PLANNING COMMISSION
REGULAR MEETING AGENDA
November 12, 2026 at 6:00 PM
Gadsden County Board of County Commissioners Chambers
Edward J. Butler Governmental Complex
9-B East Jefferson Street
Quincy

Public Hearing (Quasi-Judicial) – APC Towers IV LLC – Request for Deviations and Approval of Telecommunications Tower – Attapulgus Highway

Subject: Public Hearing (Quasi-Judicial) – APC Towers IV LLC – Request for Deviations and Approval of Telecommunications Tower – Attapulgus Highway

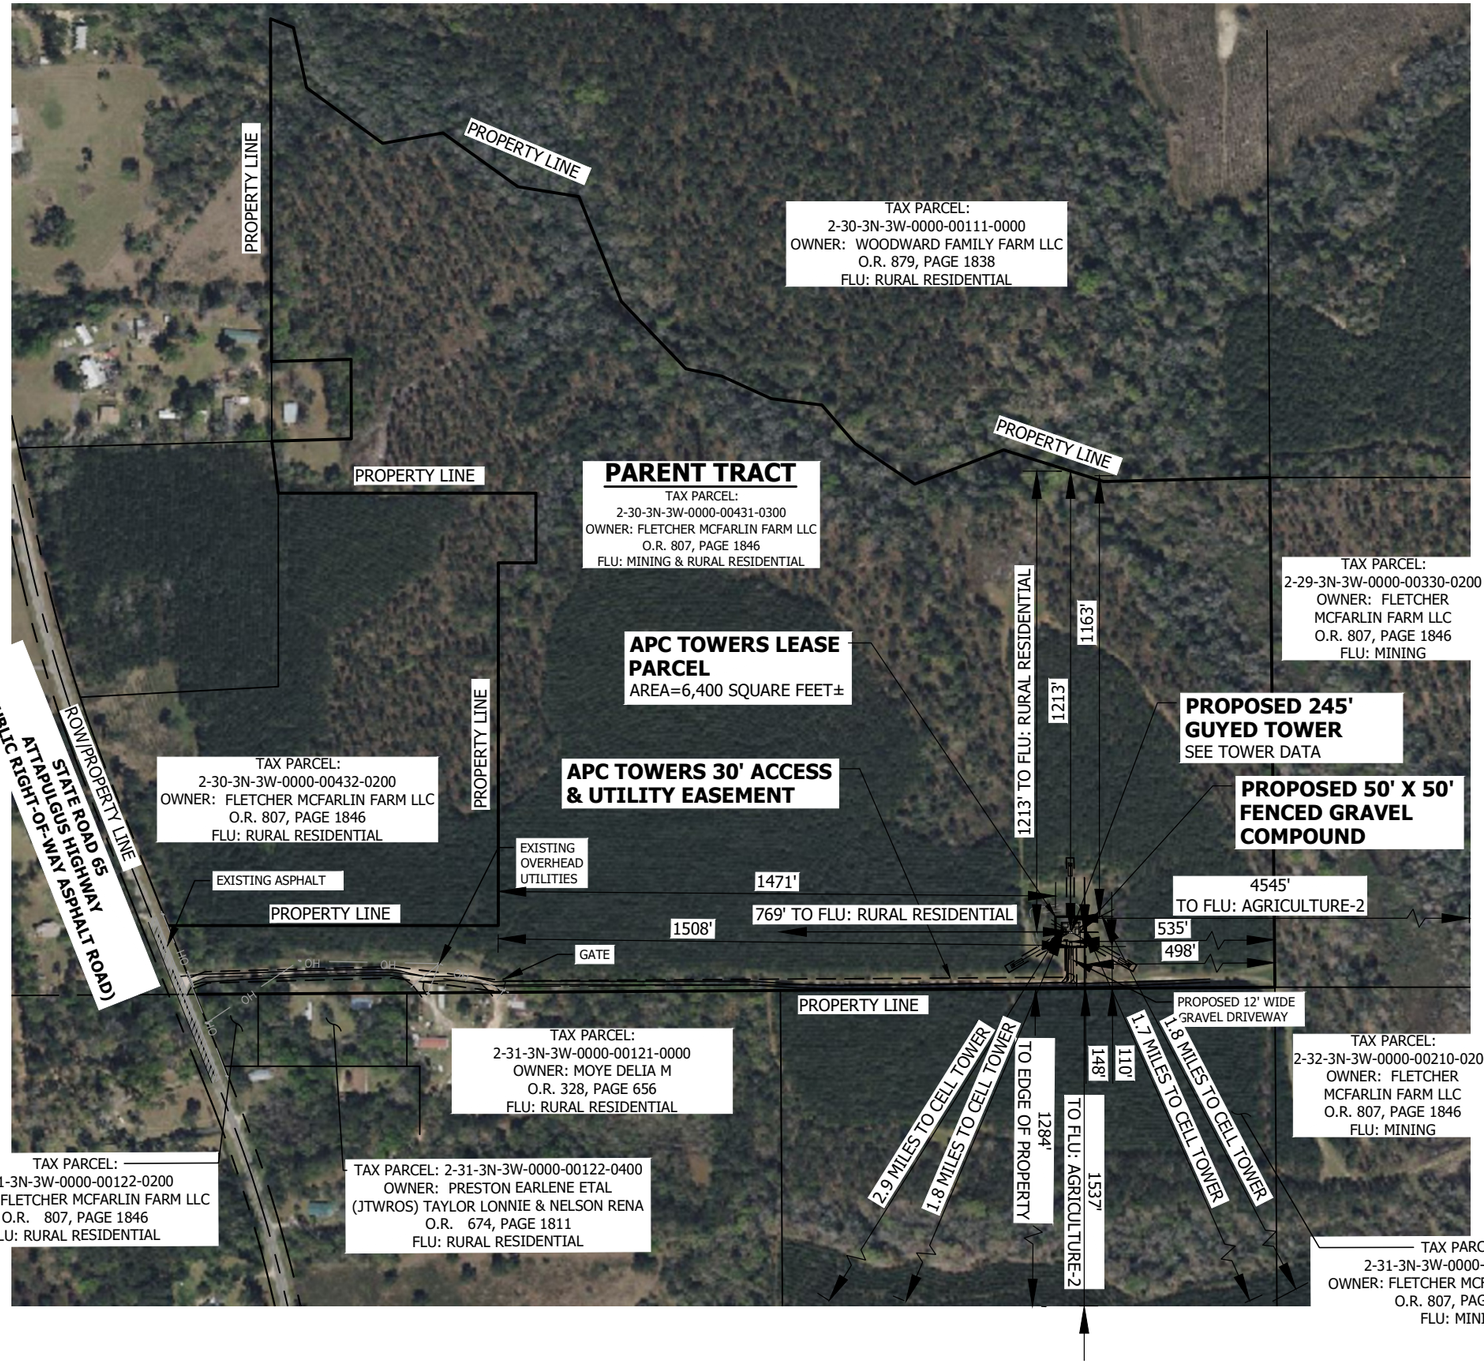
- Nearest rural residential parcel is 2-30-3N-3W-0000-00432-0200. Sheet C-1 indicates there will be 769' between the tower and this parcel.
    - A deviation is requested from this requirement.

- Sheet C-1 indicates 1.7 miles to the closest tower.
  - A deviation is requested from this requirement.

- Sheet C-1 indicates there will be a 12' gravel drive and a 30' access and utility easement; Sheet C-2/C-3 indicate a gravel turnaround area within the fenced compound.

173168_FL_1932_9JK2147 – ZD (1).dwg – Sheet:C-2 – User: dania.tamayo – Apr 09, 2026 – 4:07pm

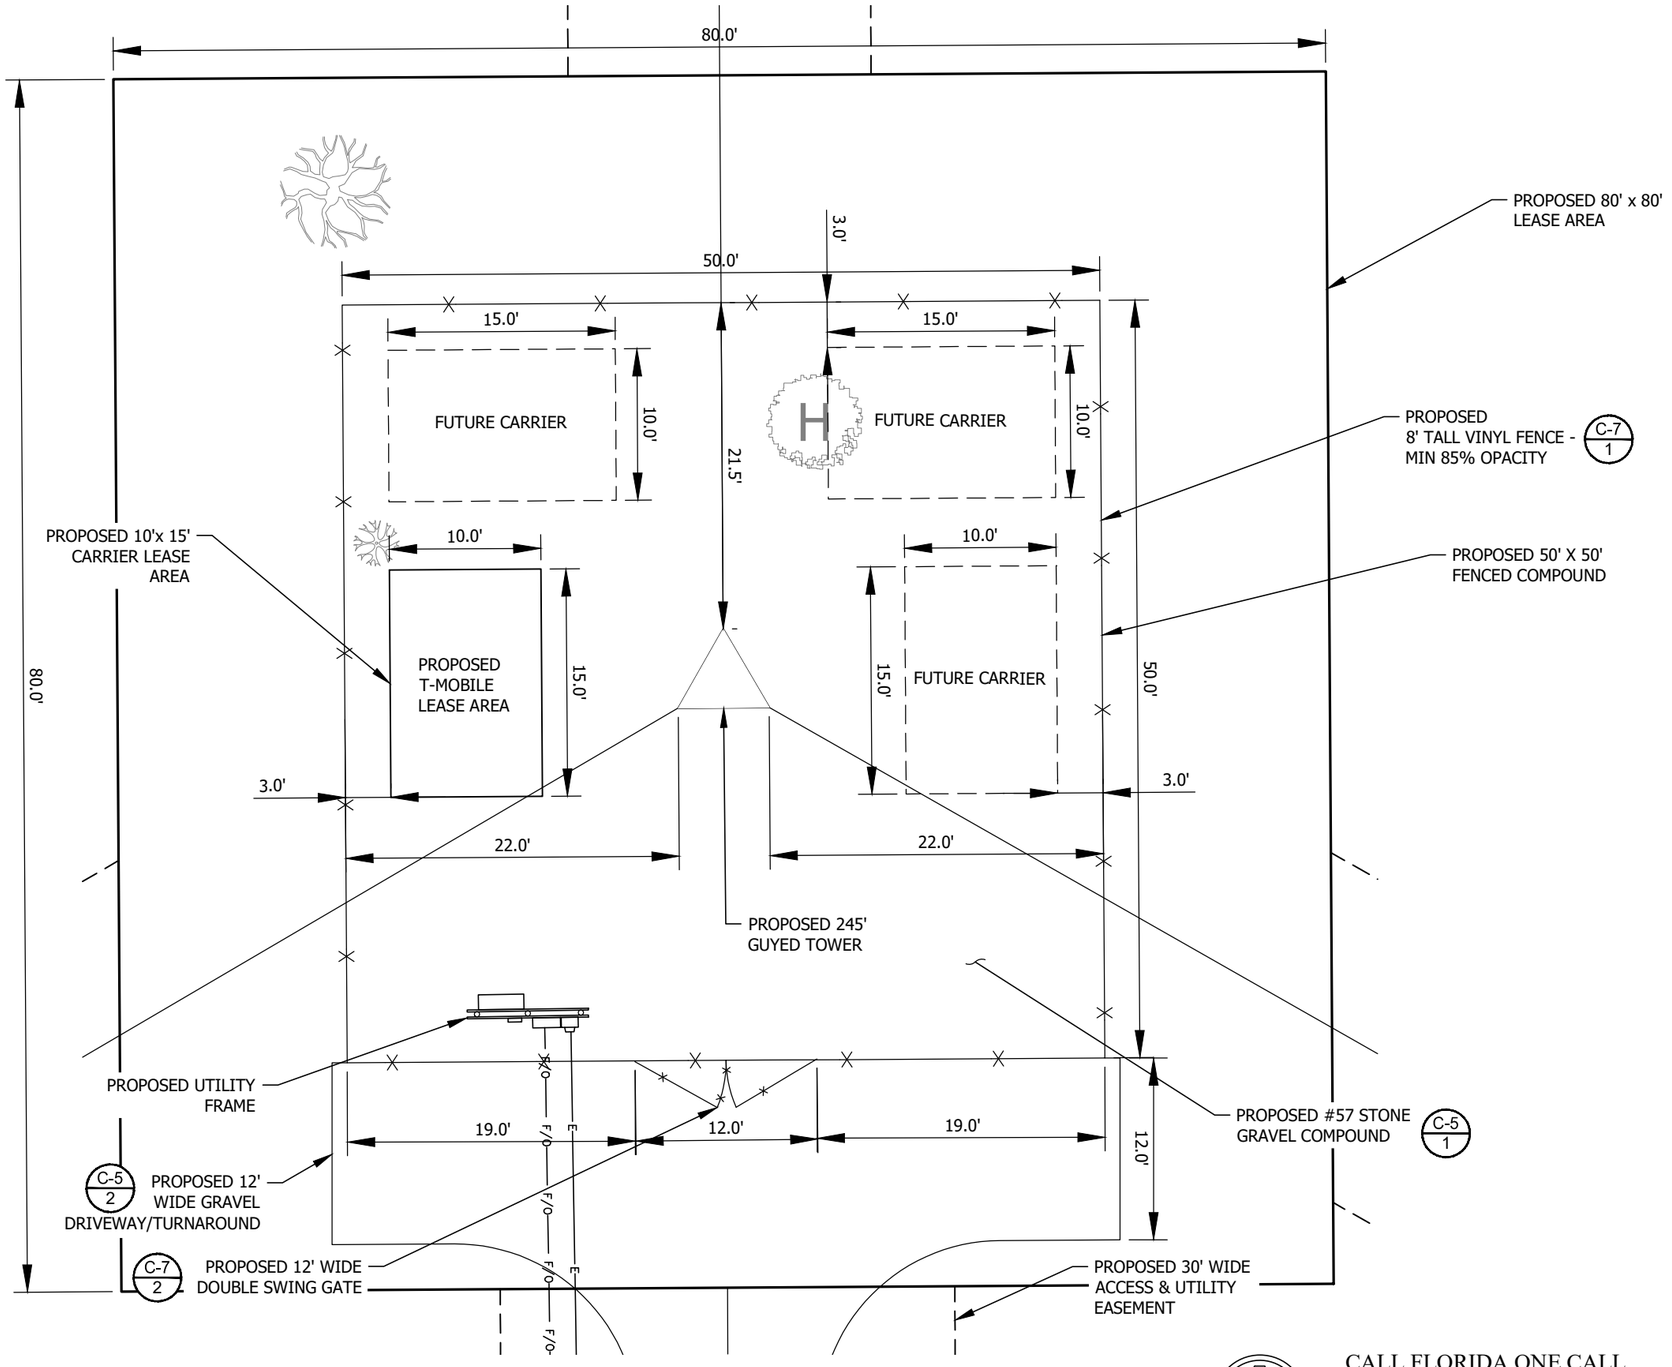
- Fall radius equals 60% of the tower height or less per provided letter; sheet C-2 indicates fall zone will be contained within subject property boundaries.

173168_FL-1932_9JK2147 – ZD (1).dwg – Sheet:C-3 – User: dania.tamayo – Apr 09, 2026 – 4:07pm

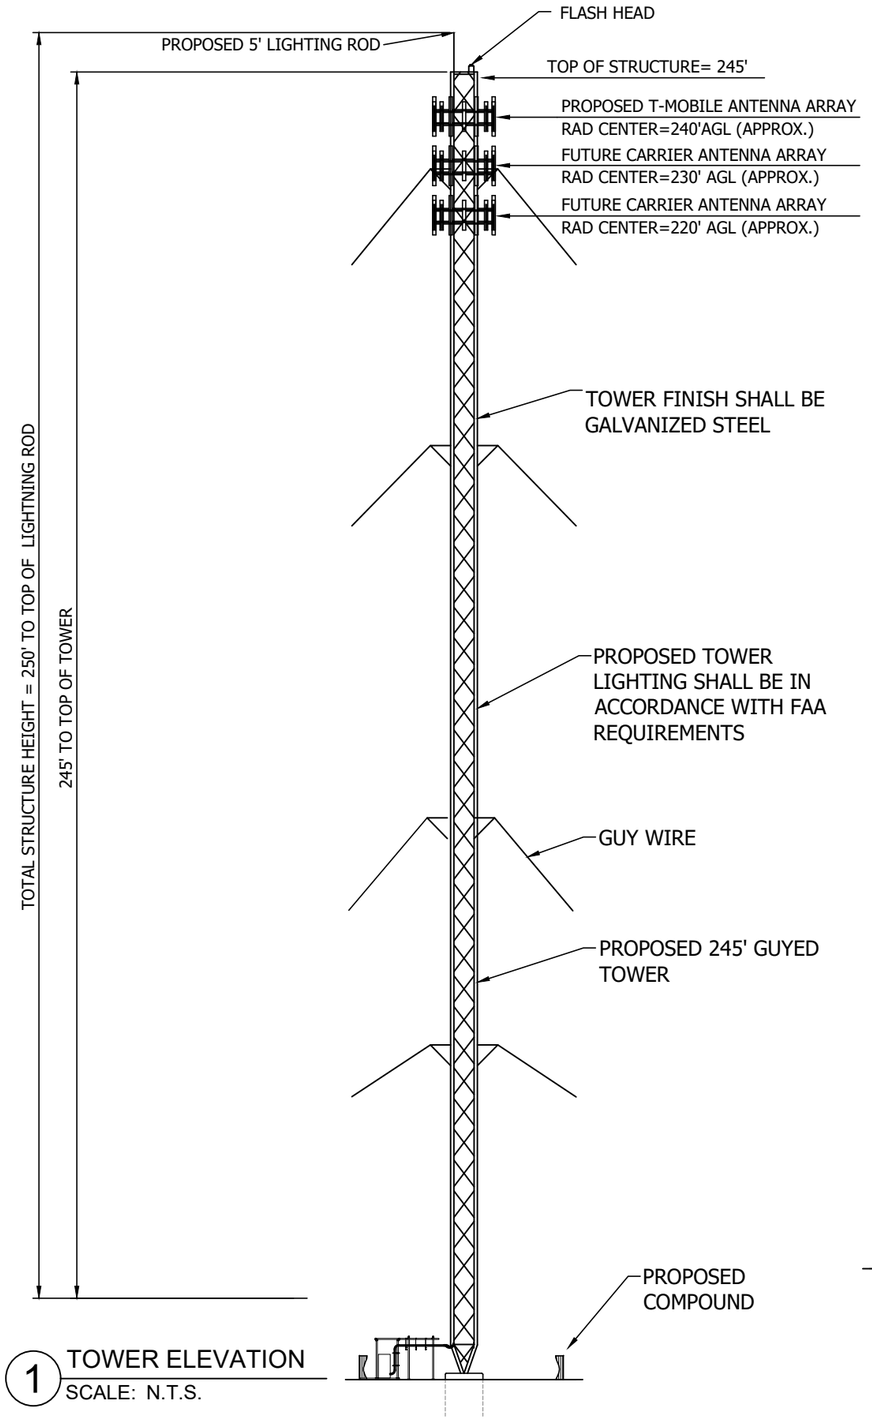
- Sheet C-3 indicates there will be a 8' fence around the tower.
        - Cover letter states the fence will be 6'. Minimum requirement met either way.

173168_FL-1932_9JK2147 - ZD (1).dwg - Sheet:C-4 - User: dania.tamayo - Apr 09, 2026 - 4:08pm

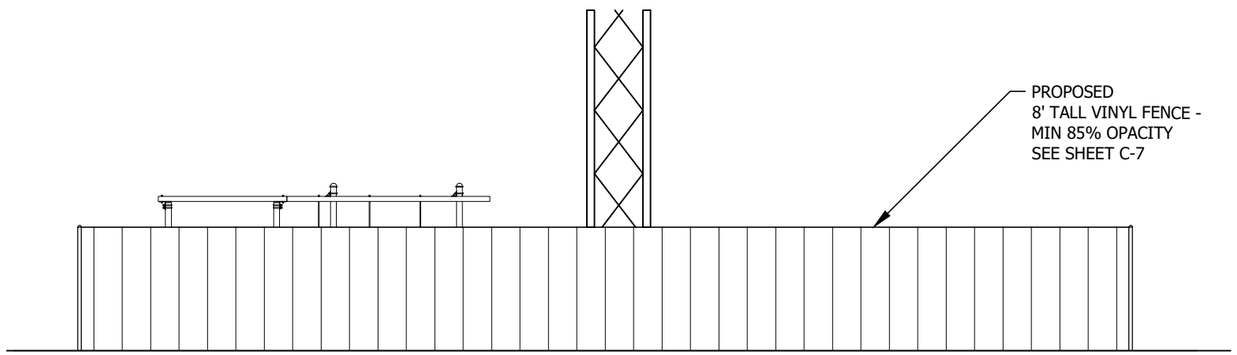
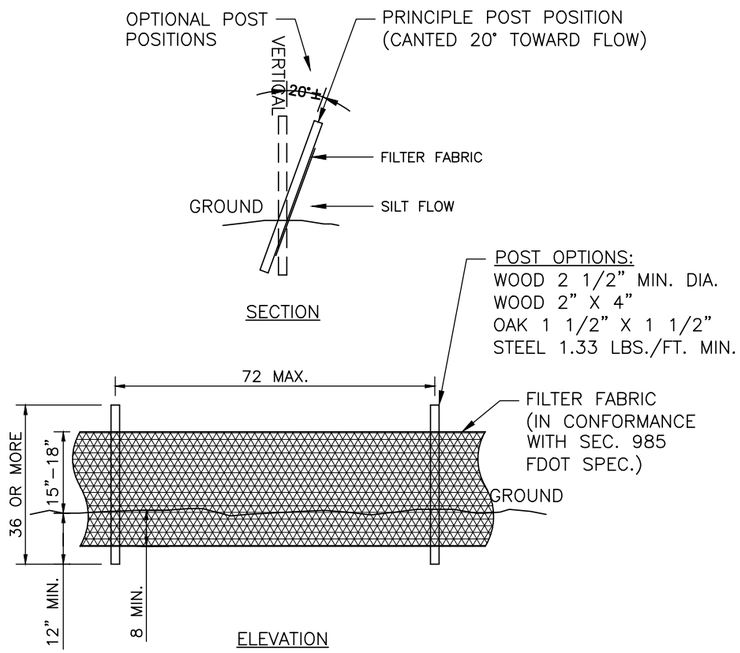
- Sheet C-4 indicates the tower will be illuminated in accordance with FAA requirements. Lights will be red.
    - **Finished Color**. Telecommunication towers not requiring FAA painting/marking shall have either a galvanized finish or painted sky blue, gray or black finish.

- Tower finished will be galvanized steel, per sheet C-4.
    - **Structural Design**. Telecommunication towers shall be designed and constructed to ensure that the structural failure or collapse of the telecommunication tower will not create a safety hazard, according to latest EIA/TIA standards, to adjoining properties. Telecommunication towers shall be constructed to the EIA/TIA standards as published by the Electronic Industries Association (EIA), all applicable building codes and as determined necessary by the Building Official.
